# UNITED STATES PATENT AND TRADEMARK OFFICE

APPLICATION NO.	FILING DATE	FIRST NAMED INVENTOR	ATTORNEY DOCKET NO.	CONFIRMATION NO.
10/714,200	11/14/2003	Stefan Ihde	67185-004	2663

<b>Office Action Summary</b>	<b>Application No.</b>	<b>Applicant(s)</b>	
	10/714,200	IHDE, STEFAN	
	<b>Examiner</b>	<b>Art Unit</b>	
	Jonathan Werner	3732

### **DETAILED ACTION**

*Figure 1 – Streel (US 4,344,757)*

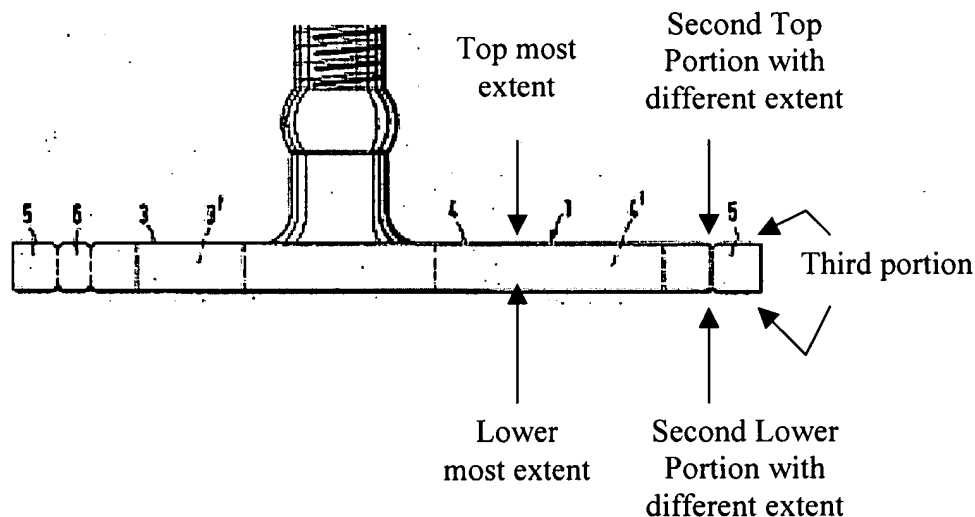
4. Claims 23-30, 35, 39 and 41-42 are rejected, as understood, under 35 U.S.C. 102(b) as being anticipated by Streel (US 4,344,757). As to claims 23 and 42, Streel discloses a dental implant comprising a post (2) having a first end a second end; said first end having a mount for a device to be implanted (Figure 3 and 5); said second end being attached to a base (Figures 1 and 2); said base being substantially orthogonal to said post in at least two non-parallel directions (Figures 1 and 2); said base having a bottom surface and said bottom surface having a lower most extent (Figure 1 below); and said base having a top surface having a first portion having a topmost extent (Figure 1 below); and at least one of said top surface or said bottom surface having a second portion having a second extent different from said topmost extent or said lower most extent (Figure 1 below). Examiner notes that no description or support of said portions are given in the applicant's specification, and hence are interpreted as previously described. As to claim 24, at least one of said top surface or said bottom surface of said base has a third portion, said third portion being equivalent to said top most extent and said third portion being separated from said first portion by said second portion (Figure 1 below). As to claim 25, Figures 1 and 2 show, for example, a first group of portions (5,6,7) having a topmost extent, and a second group of portions (8) having an extent in a direction parallel to the post that is less than the extent of the first portions. As to claim 26, the first portions (5,6,7) and the second portions (8) alternate

periodically as seen in Figures 1 and 2. As to claim 27, the first portions and the second portions are alternating corrugations (8). As to claims 28 and 29, at least one of said portions has a sharp edge (Figure 1) and at least one of said portions constitutes a ridge (Figure 1). As to claim 30, at least one of said portions constitutes a trough (8). As to claim 35, the base has an outer perimeter and said outer perimeter includes at least three substantially straight edges (Figure 2). As to claim 39, Figures 1 and 2 show the second portion is at a marginal zone of said base, said marginal zone being substantially along a portion of a periphery of said base. As to claim 41, the marginal zone comprises reentrant angles (Figure 1).
